**Product Change Notification / JAON-21SZYY684**

eSign # E000072861 Final Notice: Qualification of MSCO (Microchip - Fab 5) as an additional wafer fabrication site for selected Microsemi Silicon DQ 600V Diode PSDS (Power Switching Discrete Solutions) products.

**PCN#: JAON-21SZYY684**

Figure 1: Device “Key Parameters” Pre and Post Reliability Testing.

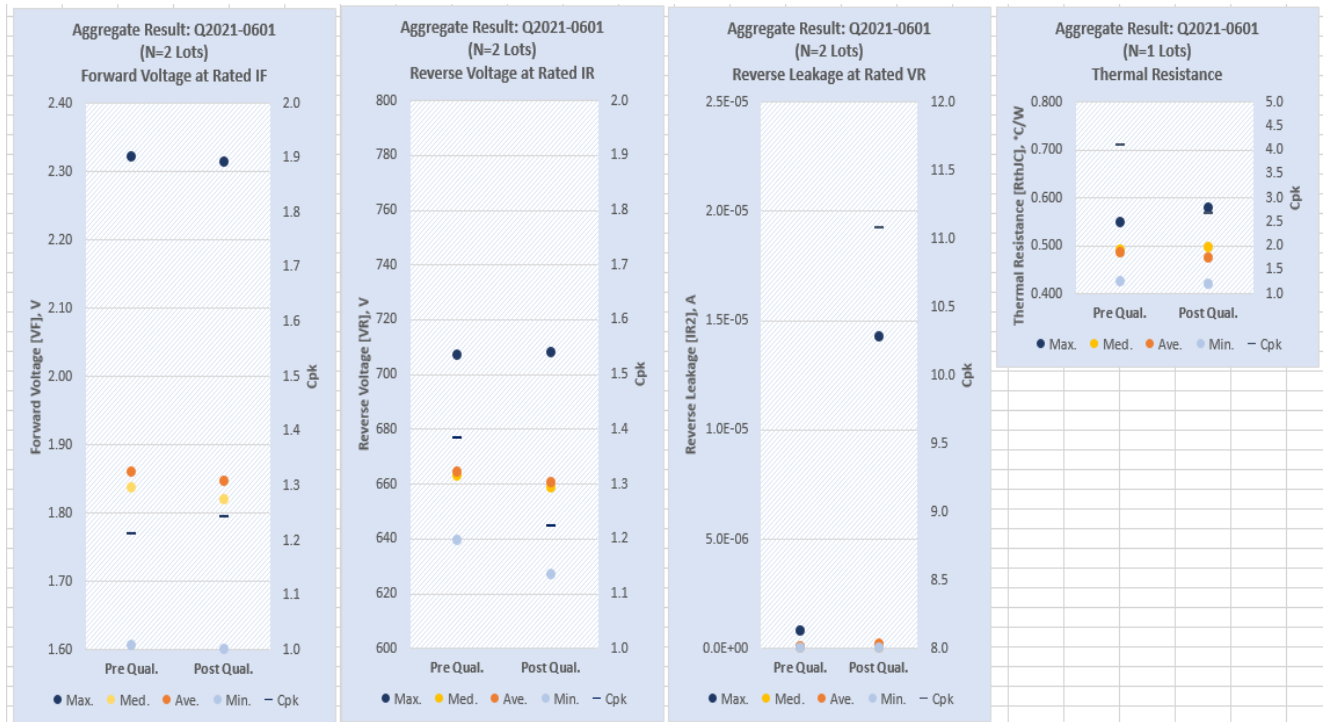
Figure 1 shows the aggregate “key” parameter results before and after the reliability tests outlined in the qualification plan for the lots from Fab 5 to meet the conditional qualification requirements.
